SERVICE LETTER No. L 132

MODEL AFFECTED: Z 242 L aircraft, S/N: 0844, 0845, 0846, 0847

SUBJECT: Corrective action to prevent hydraulic fluid leakage from the K 22-1200-7 brake.

Fig. 1 The brake K22-1200-7 (positions numbers correspond to position numbers in IPC)

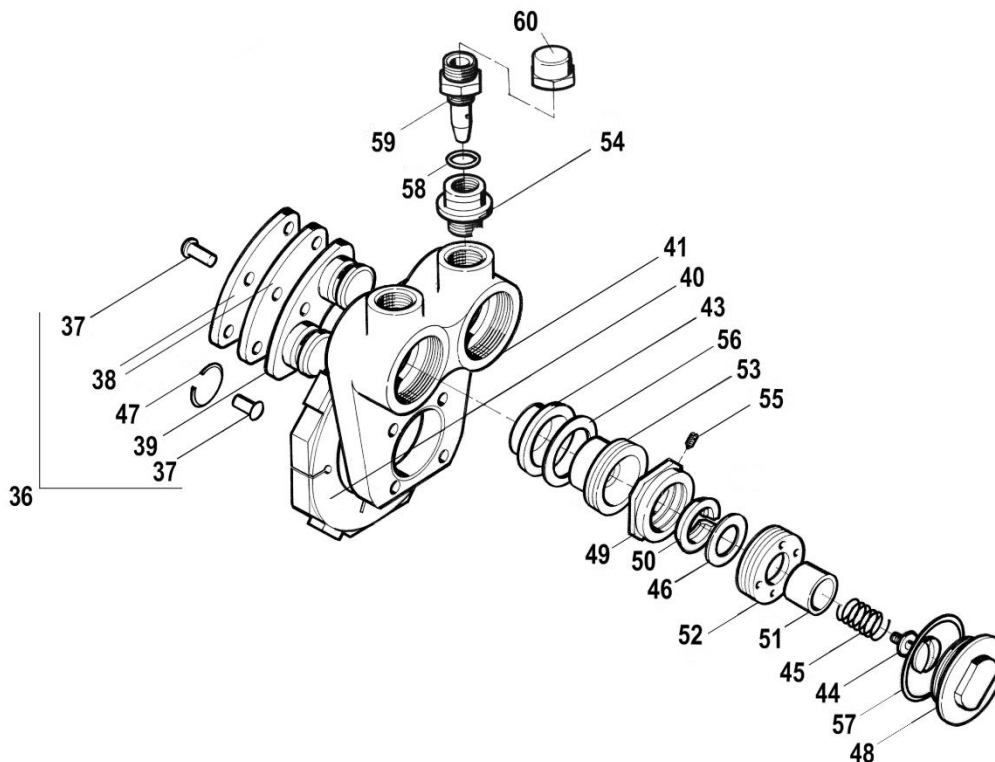
The leakage of hydraulic brake fluid can occur around the lid K22-0200.10 (item 48), as a solution of this cause, the manufacturer replaced the rubber O ring acc. to ČSN 02 9281.2 (item 57) with a dimension 48x2 with a more suitable "O" ring MS 28 775-135 with a dimension 48x2,5.

- a) Disconnect the brake from the aircraft hydraulic system (blind the outlet to the brake line). Loosen fixing screws and remove the brake from the landing gear axle,
- b) Remove the pistons (53) as follows (*performer only in case of brake leakage*):
 - loosen the lids (48) of working cylinder and push out the piston (53),
- c) Instead of the original rings (57) insert new „O“ rings (*delivered by the aircraft manufacturer*),
- d) Before reassembling the brake, wash carefully all parts with a suitable degreaser, dry them by compressed air and grease all functional parts with a suitable greaser.

NECESSARY MATERIAL: a) Based on the order, the manufacturer deliver:
466991000048 "O" RING 48x2,5 MS 28 775-135
